**Development Review Board
Panel A Meeting
April 12, 2021
6:30 pm**

- V. Consent Agenda:
 - A. Approval of minutes of the March 8, 2021 DRB Panel A meeting
- VI. Public Hearings:
 - A. **Resolution No. 388. Canyon Creek 8-Lot Subdivision: Scott Miller, SAMM-Miller LLC – Applicant for William Z. Spring and Fallbrook, LLC– Owners.** The applicant is requesting approval of a Comprehensive Plan Map Amendment from Residential 0-1 Dwelling Units per Acre to Residential 4-5 Dwelling Units per Acre, a Zone Map Amendment from Residential Agriculture-Holding (RA-H) to Planned Development Residential 3 (PDR-3) and adopting findings and conditions approving a Stage I Master Plan, Stage II Final Plan, Site Design Review, Type C Tree Plan, Tentative Subdivision Plat, and Waiver for an 8-lot residential subdivision located at 28700 and 28705 SW Canyon Creek Road South. The subject site is located on Tax Lot 6400 and a portion of Tax Lot 3800 of Section 13BD, Township 3 South, Range 1 West, Willamette Meridian, City of Wilsonville, Clackamas County, Oregon. Staff: Philip Bradford

A RESOLUTION ADOPTING FINDINGS RECOMMENDING APPROVAL TO CITY COUNCIL OF A COMPREHENSIVE PLAN MAP AMENDMENT FROM RESID

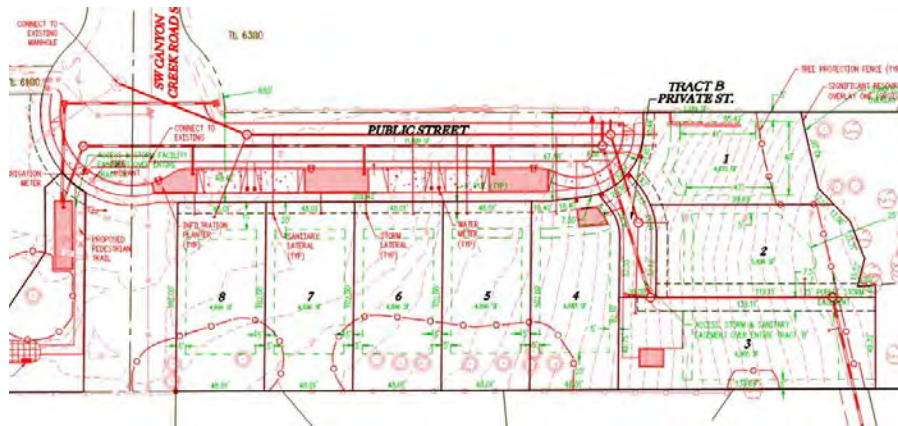
However, the arborist report notes that several of the trees shown as preserved along the rear lot lines for lots 4-8 should be reevaluated against the future home plans as the tree protection fencing overlaps with the buildable area of the proposed lots (shown in the image below delineated by green dashed lines). It is important the tree protection fencing is realistic and easy to maintain as fencing ensures construction impacts will not impact the root zones of the trees and increases the likelihood the preserved trees will survive after construction is complete. Staff has witnessed similar situations in other projects and in order to preserve the trees to the greatest extent possible, a condition of approval has been added to reassess the trees with the project arborist when the future house plans are provided to ensure maximum preservation. In the case that tree removal is requested for one of the trees indicated for preservation, the project arborist will submit a report to City Staff including a written explanation of the measures considered to preserve the trees along with the reasoning that makes preservation not feasible.

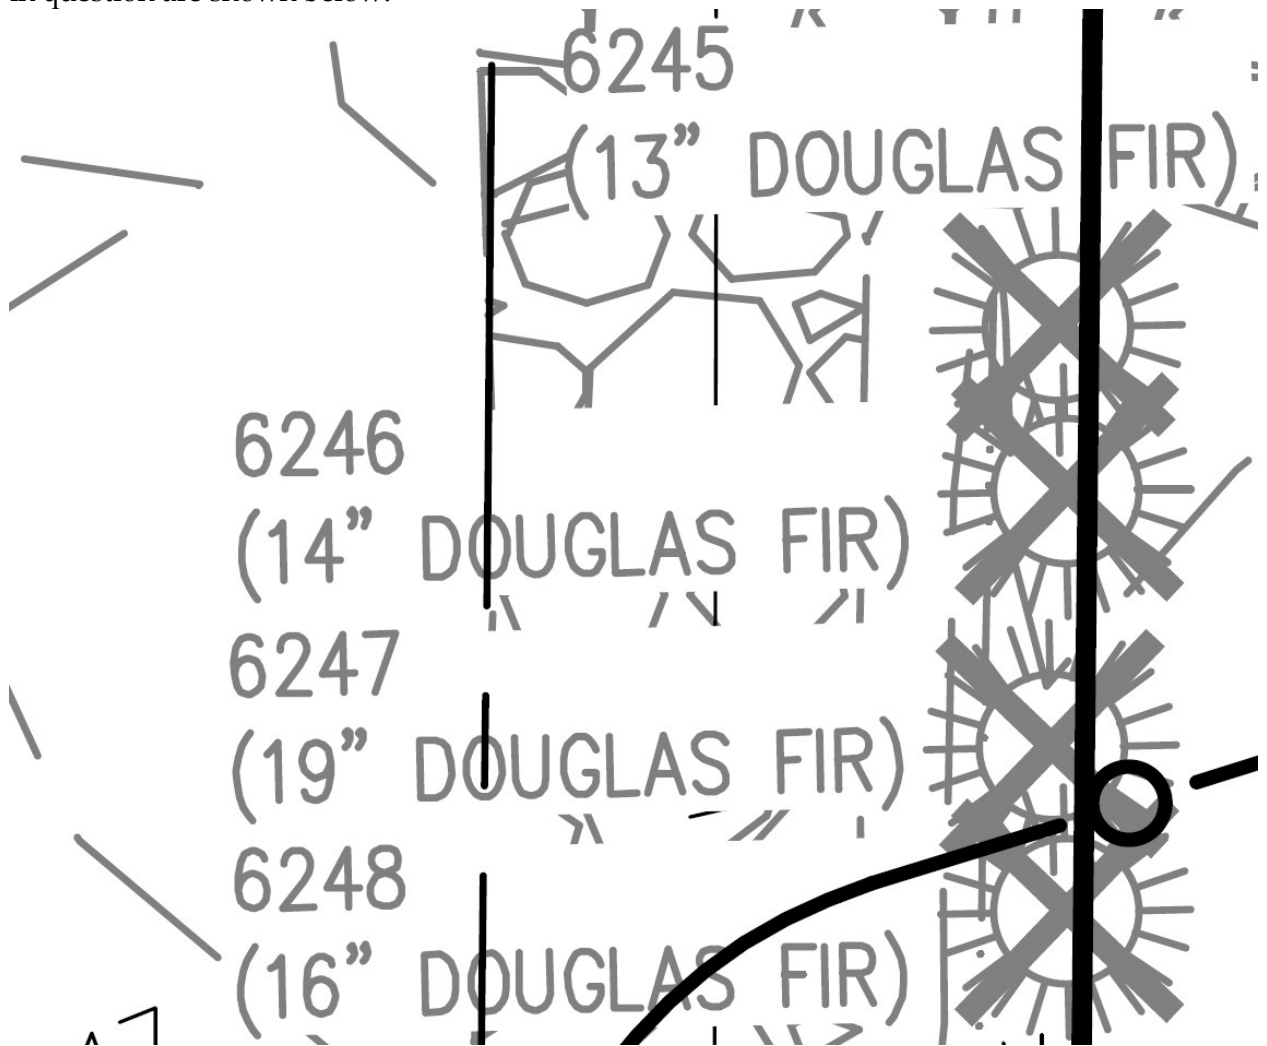
Staff questioned the applicant on the proposed tree preservation plans as they relate to the construction of future homes on the newly created lots. The applicant’s response contained in Exhibit B5 states: *“The submitted tree preservation and removal plan is specific to the construction of the subdivision only and does not include potential tree removal to accommodate the future homes. Any necessary tree removal required for lots 4-6 and 7 to accommodate future dwellings will be addressed during the building permit review process.”*

By time of this staff report publication, the Applicant did not submit new exhibits showing modified building envelopes. Nor did the Applicant submit new findings and exhibits to modify the tree removal and protection plan as a result of a reduced buildable area that would not be feasible. As such, staff has included Condition of Approval PDF 9 that requires an assessment and written report by an arborist if any of these preserved trees are proposed for removal in the future due to construction; the report must provide a written explanation of the measures considered to preserve the trees along with the line of reasoning that prevents preservation, submitted to City staff, who will verify the validity through review by a second arborist.

In addition to the issues concerning the trees at the rear of lots 4-8, the trees proposed for removal along the western property line of Lot 8 appear to be on City of Wilsonville property and the applicant does not have City permission to remove these trees. The trees in question are shown below:

Condition of approval PDF 8 requires Tree Numbers 6245 (13" Douglas Fir), 6246 (14" Douglas Fir), 6247 (19" Douglas Fir), and 6248 (16" Douglas Fir) shall be retained unless City approval and signature is granted for these four (4) trees. The applicant shall revise the tree protection fencing plan to ensure these trees are properly protected during grading and construction.

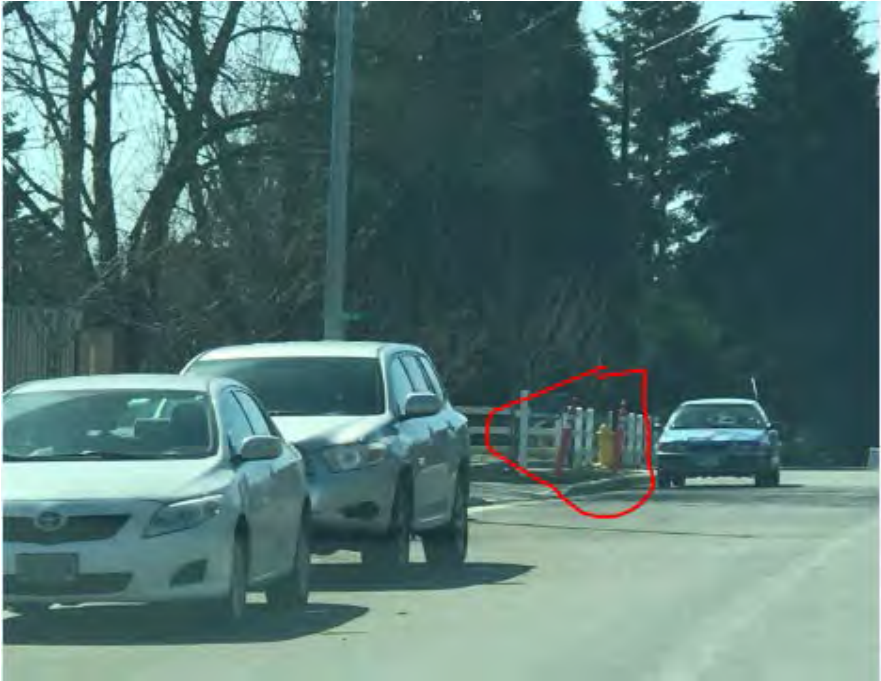
Trees in red area proposed for removal

A Wall of 3+ homes will be behind a property with one home!

This grove of trees will be removed for a community garden for 8 homes?
